BGS #3478

Bradbury Mountain State Park Campground

## **Addendum #2**

Summary :

**Sheet C-6.2 Campsite Sewer Hook Up Detail.**

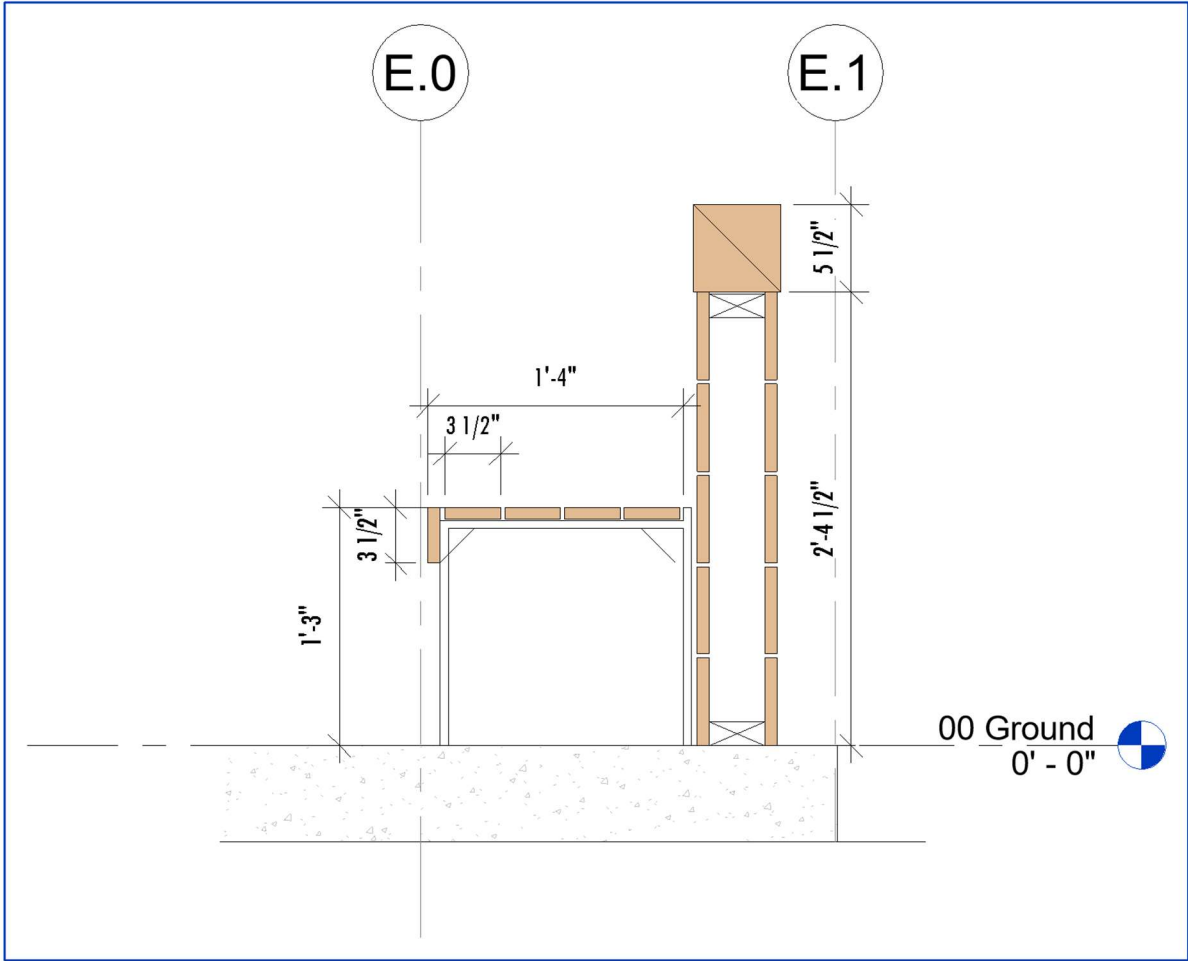
15. Is there a detail for the RV dump station connection point?

**DETAIL FOR BENCH / KNEE WALL:**

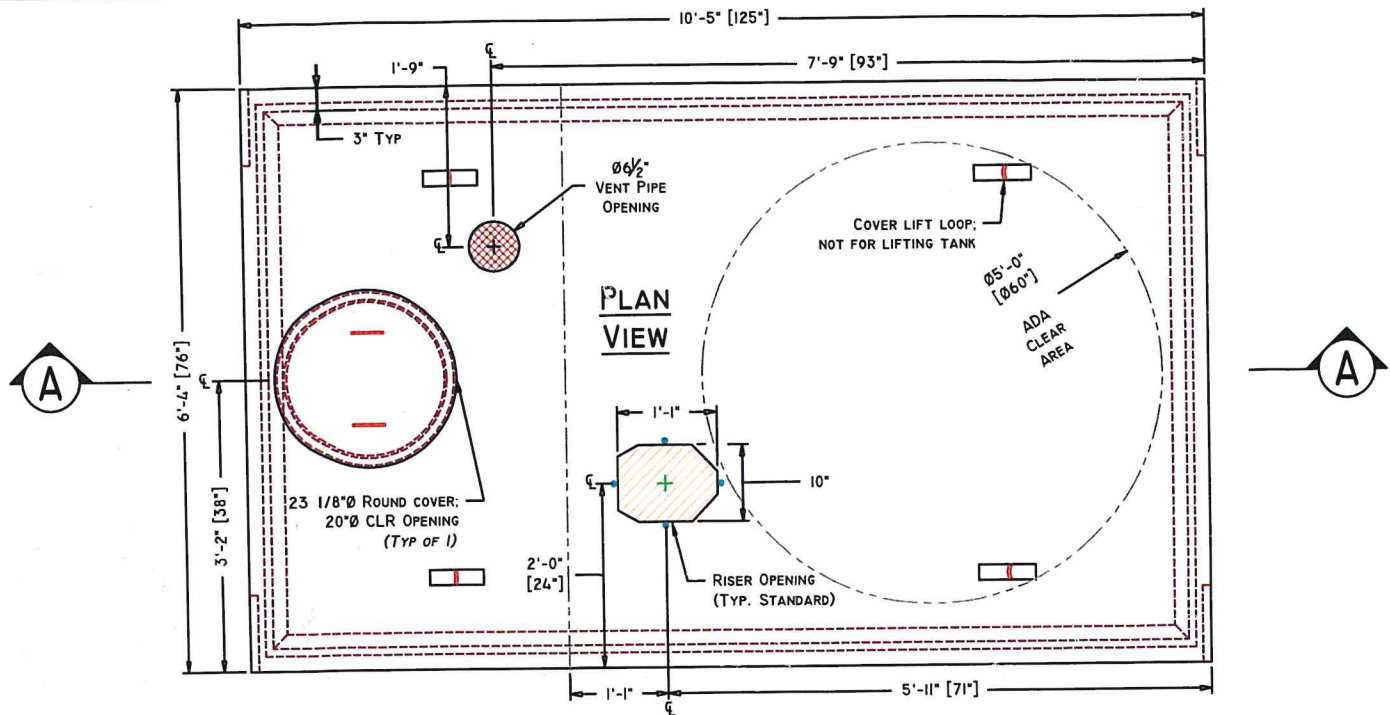
10. On drawing A1.101 the clouded elevation reference and enlarged plan areas are not identified. There appears to be a bench/knee wall area – is this part of the contract? If so, can you provide a wall type and bench materials?

**THIS IS PART OF THE BASE BID. SEE DETAIL AT END OF ADDENDUM**

## 1000 GALLON LOWBOY PRIVY TANK

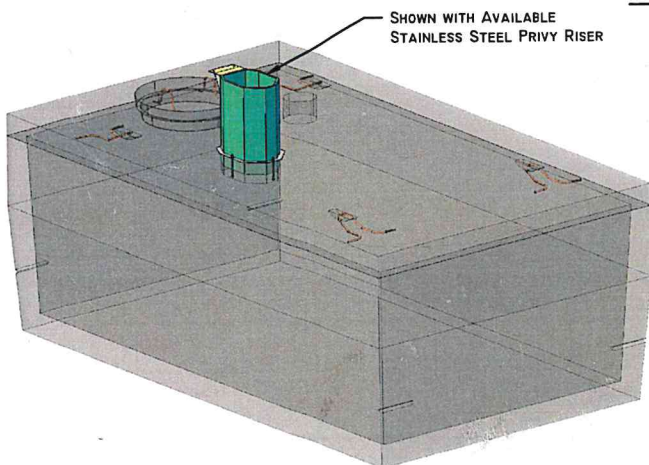
7. Who is providing vault toilets? If the contractor please provide details and requirements

**Contractor purchases and installs the vault privy base based on the spec proved by BPL, or approved equal**
